## Amended Section 75W to Concept Plan (MP10\_0003)

### Discovery Point, Wolli Creek

Submitted to Department of Planning and Infrastructure  
On Behalf of Discovery Point Pty Ltd

April 2012 ■ 09642

**Figure 2 – Impact on Building 11 from complying with 60% solar access requirement**

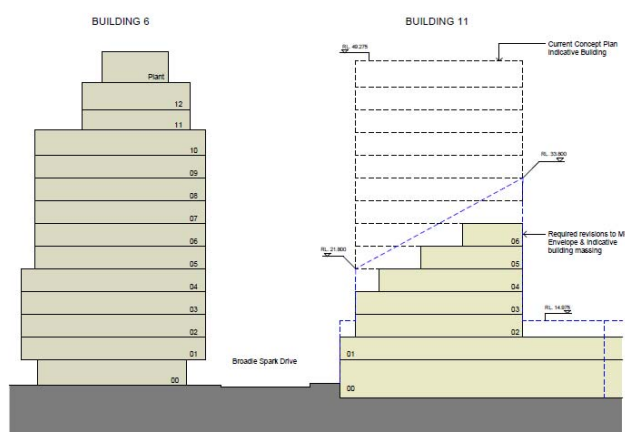
Australand have also investigated the implications of Building 6 achieving compliance with the 60% Concept Plan solar access condition. The results from these investigations are provided at **Figures 2 and 3**). In summary, significant areas of GFA from future Building 7 (over approximately 3,500m<sup>2</sup> of GFA) and Building 11 (over approximately 5,000m<sup>2</sup> of GFA) would need to be removed in order for Building 6 to reach close to the 2 hour solar access requirement. Such significant reductions in GFA will have substantial implications on the viability of the development and is accordingly not a feasible option for the site development. This would obviously then have flow on effects in terms of placing further pressures on housing supply and affordability in Rockdale LGA and NSW more broadly.

In addition, reducing the GFA and yield of Building 11 and Building 7 will also have detrimental impact on the solar access performance of these buildings as there will be significantly less apartments left that will be able to achieve 2 hours of solar access.

**Figure 6** – Updated building separation diagram for approval

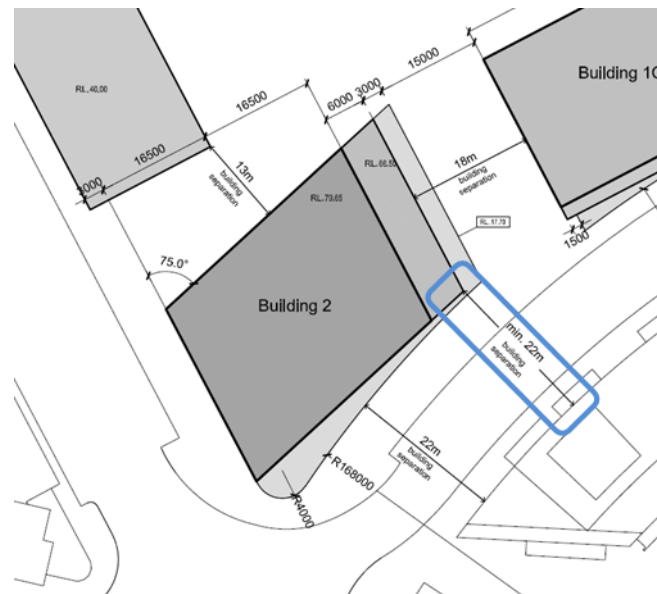
In the process of documenting the Building 2 Development Application, it has become evident that there is a minor drafting error within the approved Concept Plan Proposed Building Envelopes drawing (DA3-001 Revision D dated 23/02/2011).

The drafting error relates to the position of the 22 metre building separation arrow between Building 2 and the existing building Verge (refer to **Figure 4**). The dimension arrow on the approved drawing is to the balcony edge. The dimension arrow in this case should carry beyond the balcony to the facade. The original reason the 22 metre dimension was labelled on the Concept Plan drawing was to establish a building separation distance less than the Residential Flat Design Code (RFDC) 'Rule of Thumb' for Levels 9 and above only (which do not have balconies).

However the distance between Building 2 and Verge main facade varies from the RFDC 'Rule of Thumb', which require a 24 metre separation for level 9 and above (**Figure 5**). This was justified within the Concept Plan EAR and PPR. As Building 2 would be located at a minimum distance of 22 metres from level 9 – 11 of Verge, a 22 metre dimension arrow was intended to be placed between the main façade of Verge and Building 2 to depict this variation (**Table 1**).

A minor drafting error accordingly occurred in translating the 22 metre dimension arrow on the Building Envelopes drawing. To correct this error, it is requested that the accompanying revised Building Envelopes drawing (DA3-001 rev G - included at **Appendix A**) be added to the plan list at Condition A2 of MP10\_0003 and replace the previously approved version. **Figure 6** provides an extract of the corrected placement of the 22m dimension arrow between Building 2 and the main façade of Verge.
